Site Section DD Scale 1:500

Site Section EE Scale 1:500

London School Of Hygiene & Tropical Medicine TP2 LONDON SCHOOL of HYGIENE STROPICAL MEDICINE

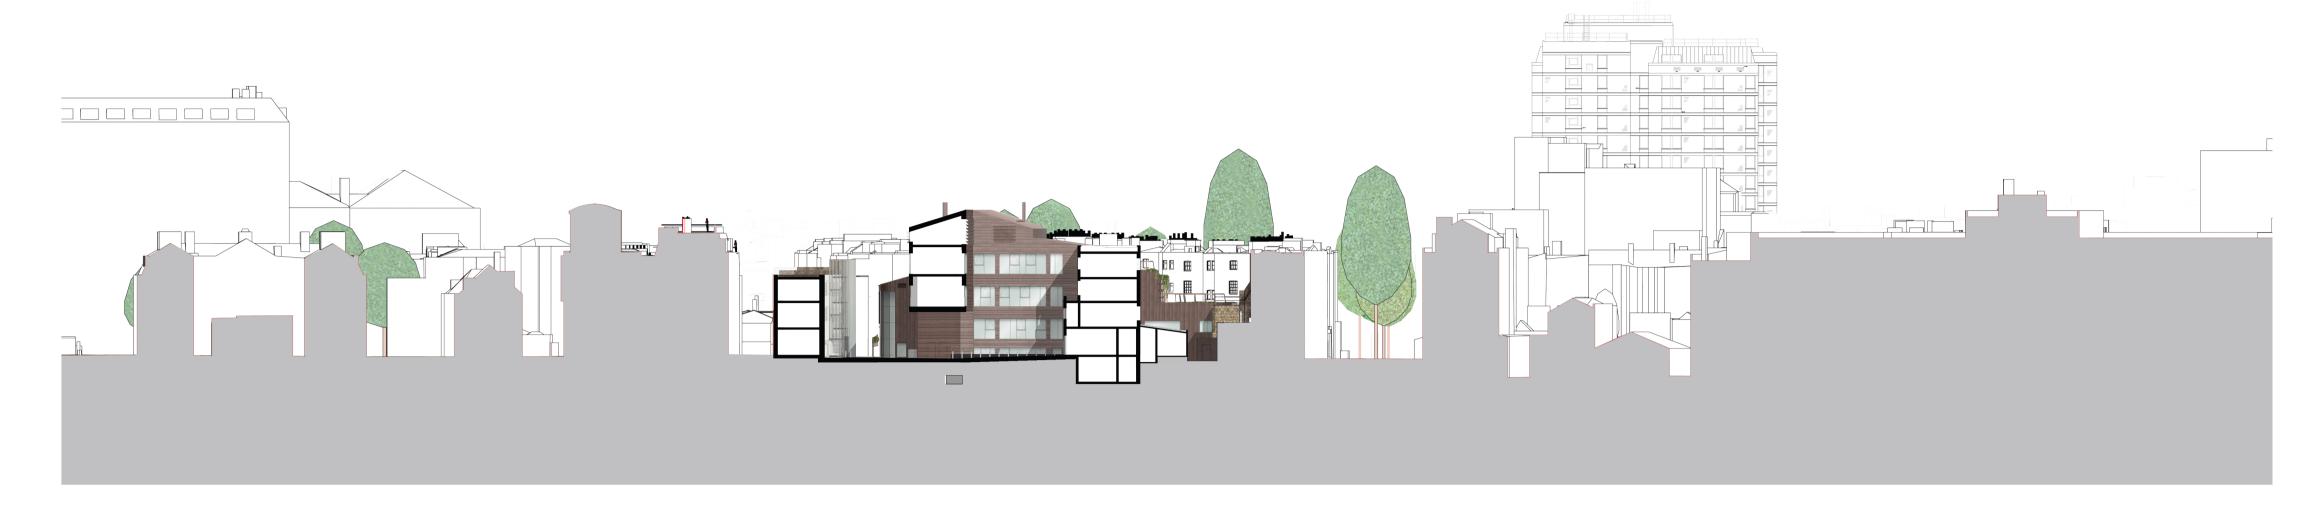
REFER TO SOUTH ELEVATION CHANGE MARK-UP AND WEST ELEVATION CHANGE MARK-UP FOR CHANGES.
